UNITED STATES DEPARTMENT OF COMMERCE
Patent and Trademark Office

APPLICATION NO.	FILING DATE	FIRST NAMED INVENTOR	ATTORNEY DOCKET NO.
09/144,920	09/01/98	GRIFFIN	4990.21

Office Action Summary

Detailed Office Action

Fig. 9. Experimental procedure for measuring the insertion loss of an optical fiber taper. (a) Establishing the power level reference, (b) Measurement of insertion loss.

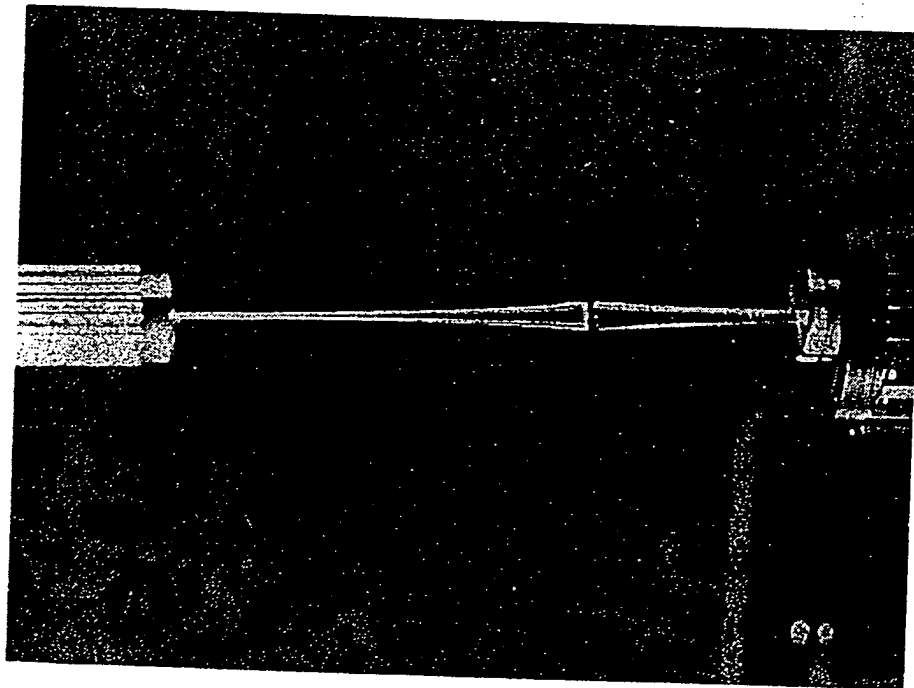
With respect to claim 22, based on the assumption from above, JOLT in January discloses an optical assembly comprising (please see the attachment A): an illumination fiber (fig 9, 1), a first taper fiber section (fig 9,2), a collection fiber (fig 9,4).

With respect to claim 24, the collection fiber section comprising: a second tapered fiber section (fig 9, 3) and the light output end has a smaller diameter than the light input end.

With respect to claim 28, fig 9 in JOLT (please see attachment A) discloses the output of the first tapered fiber (fig 9, 2) and the input end (fig 9, 3) of the collection fiber are coupled to one another.
